ADDENDUM NO. 2

Reference: UVU Student Life Center & Parking Structure
Orem, Utah
DFCM Project No. 10289790

STUDENT LIFE CENTER & PARKING STRUCTURE

The original specifications and drawings, dated April 27, 2012 for the project referenced above are amended in this Addendum No. 2, dated May 04, 2012.

A1 / SB-101a FOOTING & FOUNDATION PLAN - ZONE A

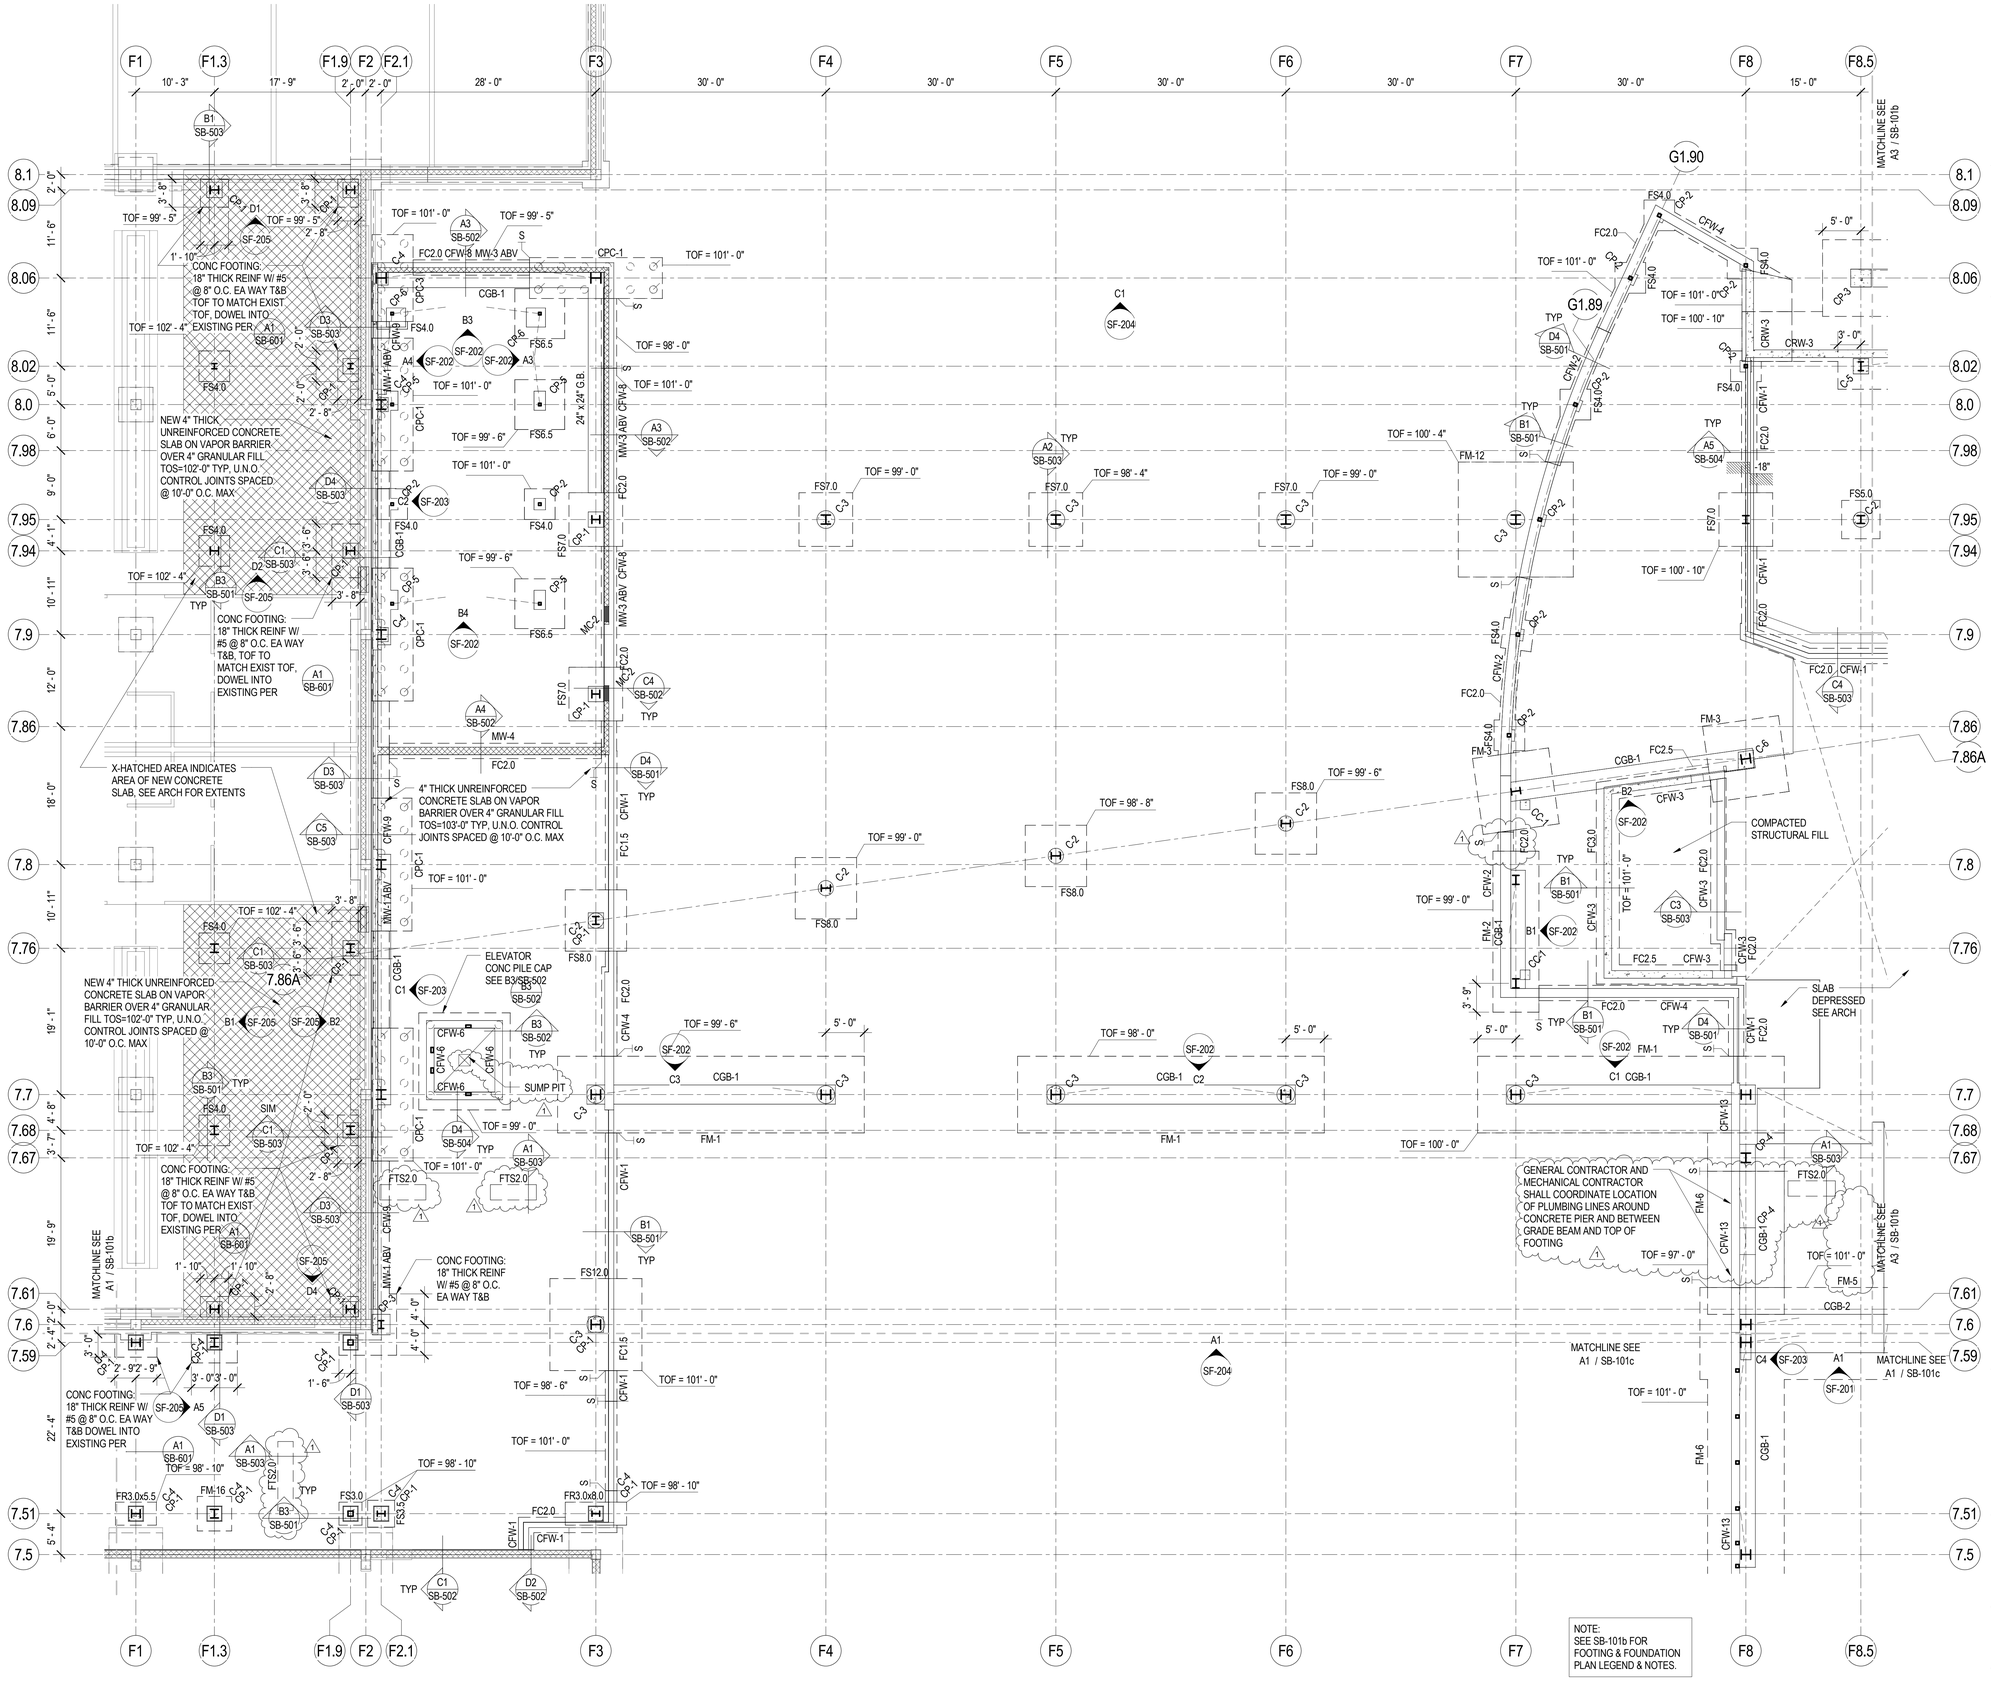
Sheets SB-101a:
1. See revised partial footing and foundation plan area A.

A1 SB-101b FOOTING & FOUNDATION PLAN - ZONE A CORRIDOR

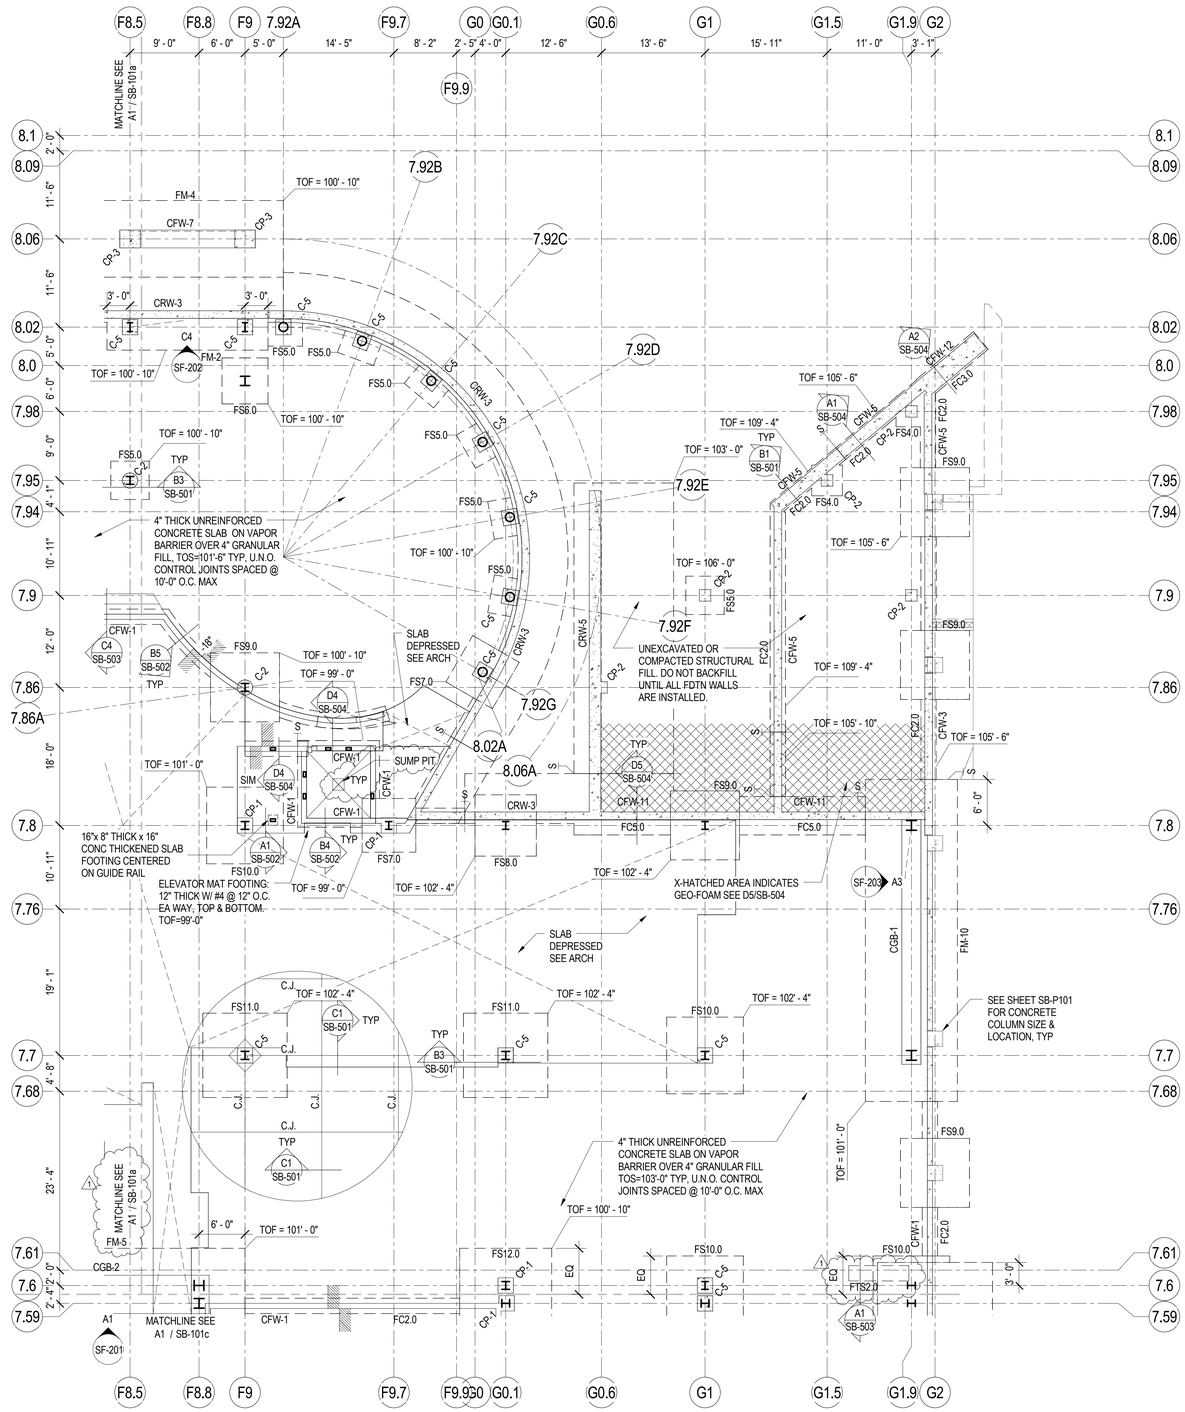
Sheets SB-101b:
1. See revised partial first floor footing and foundation plan area B.

A1 SB-101c FOOTING & FOUNDATION PLAN - ZONE C

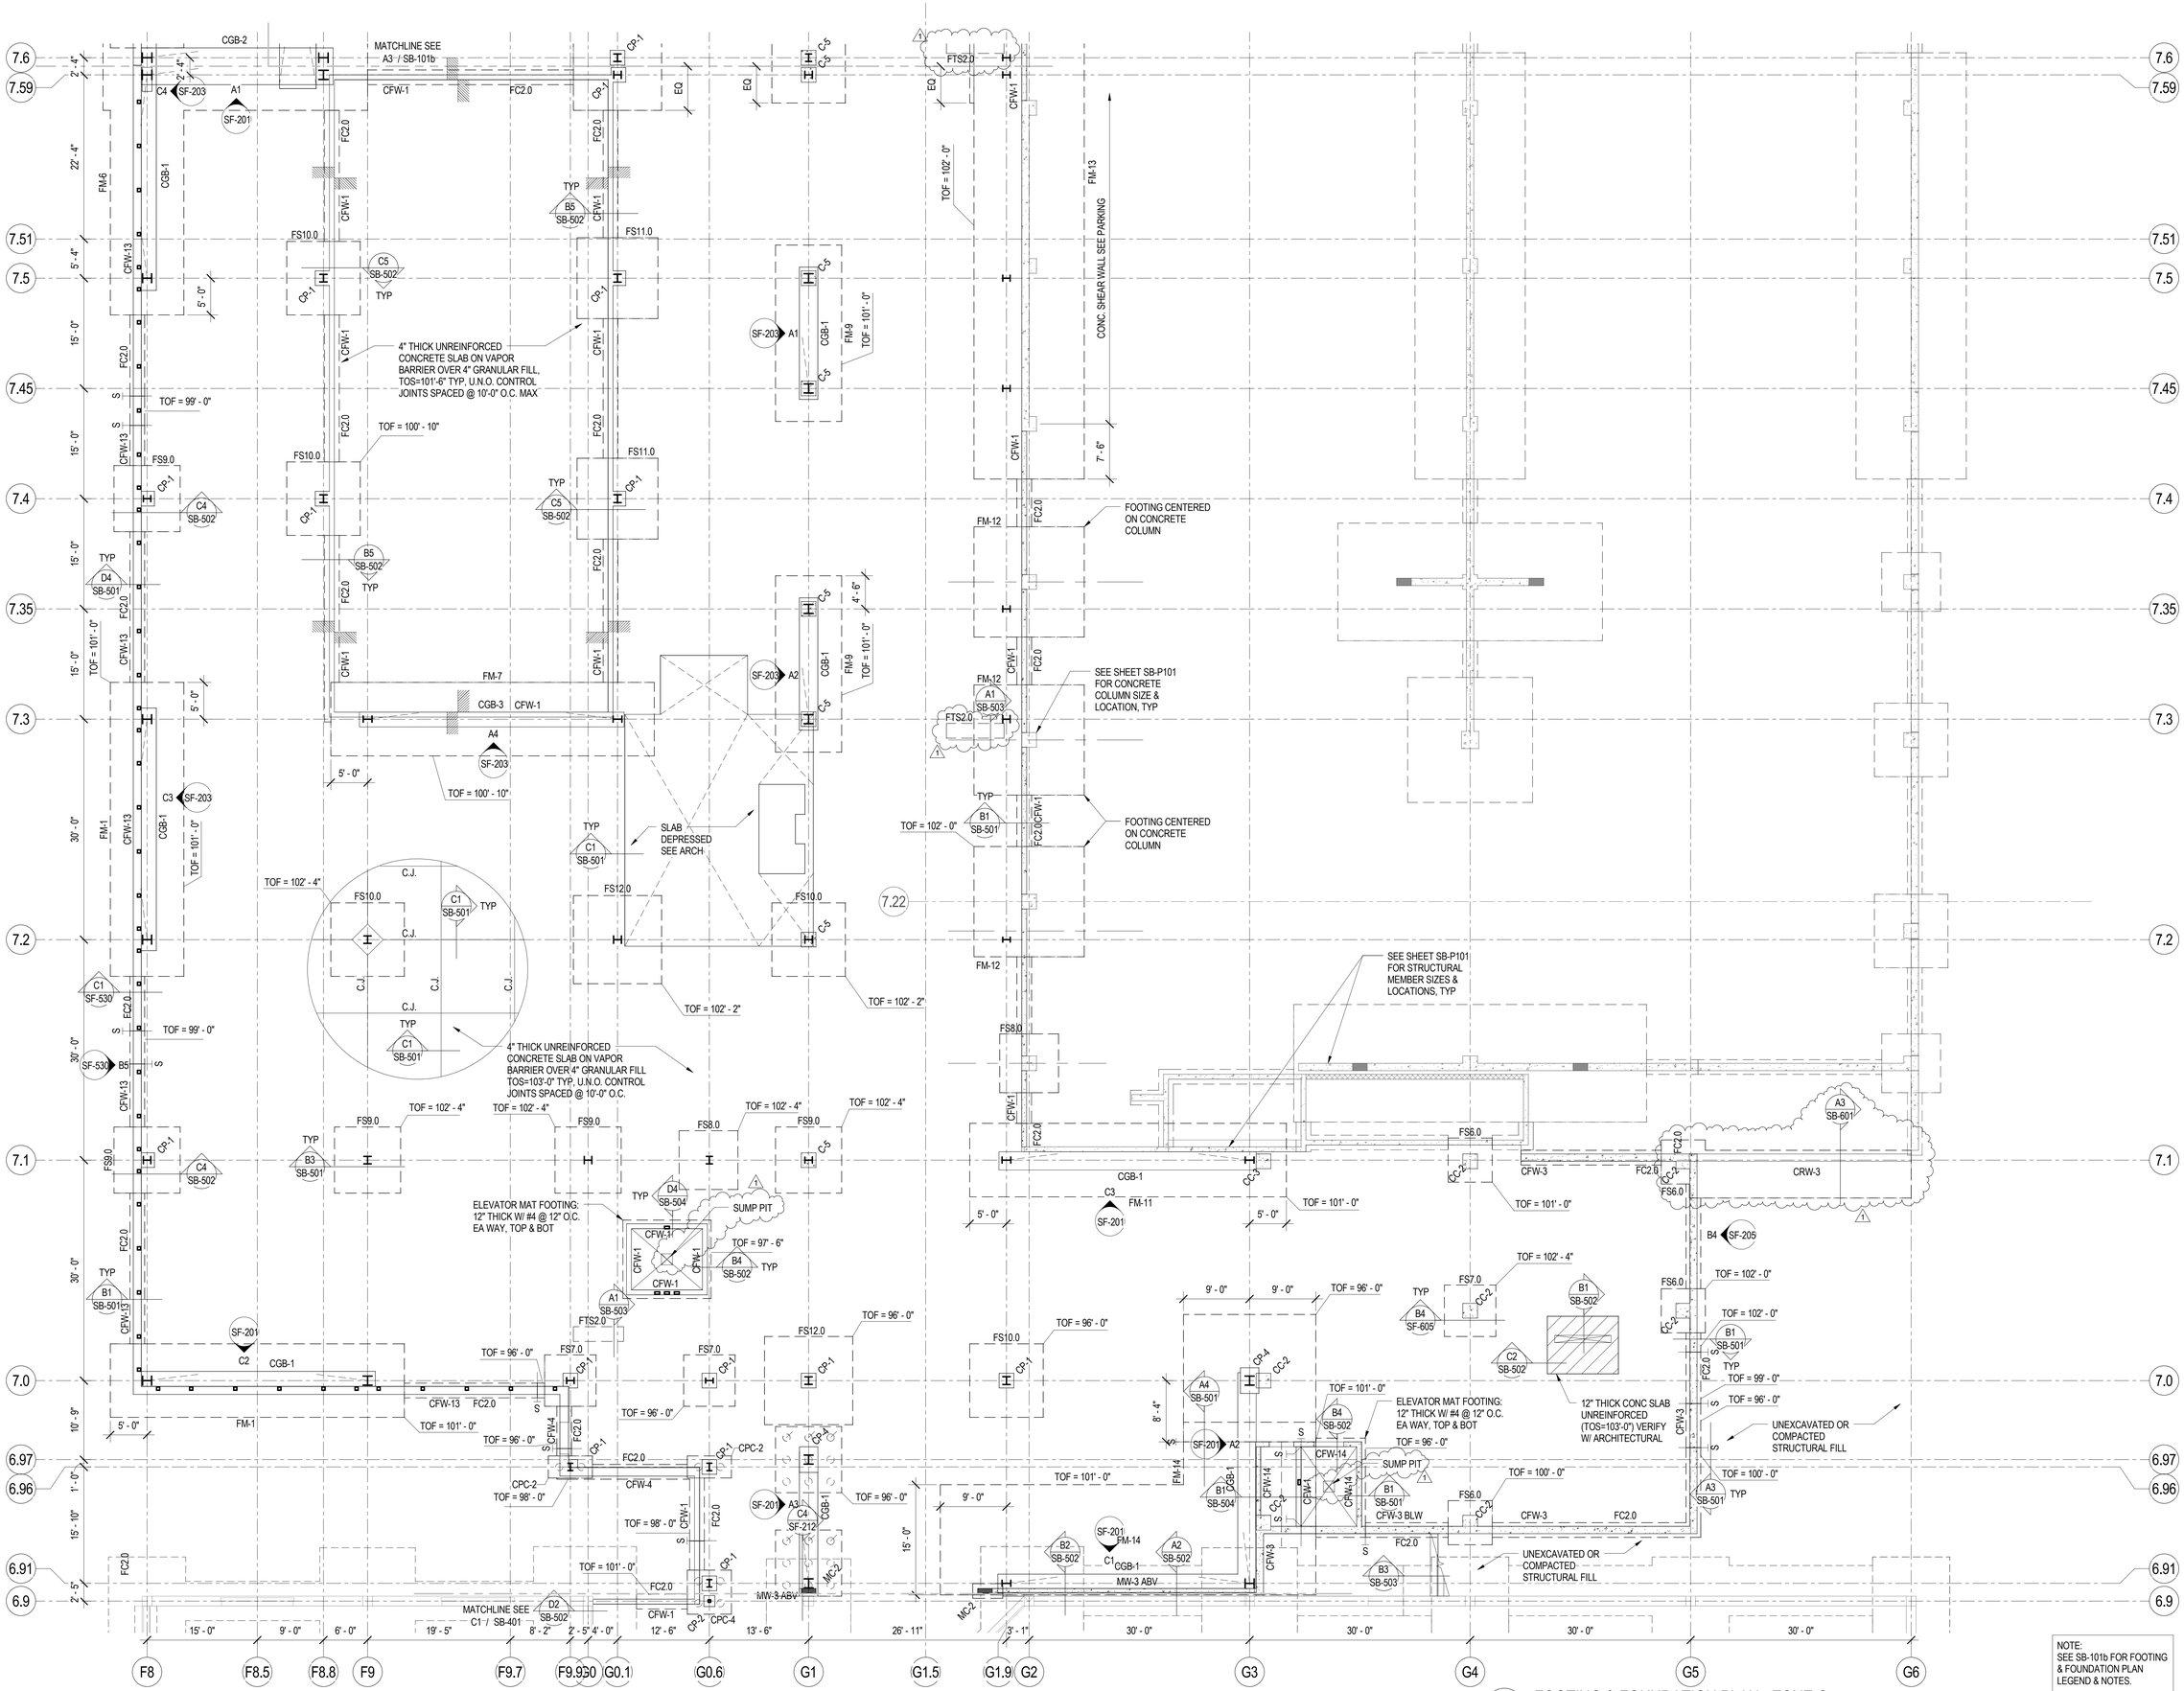
Sheets SB-101c:
1. See revised partial first floor footing and foundation plan area C.
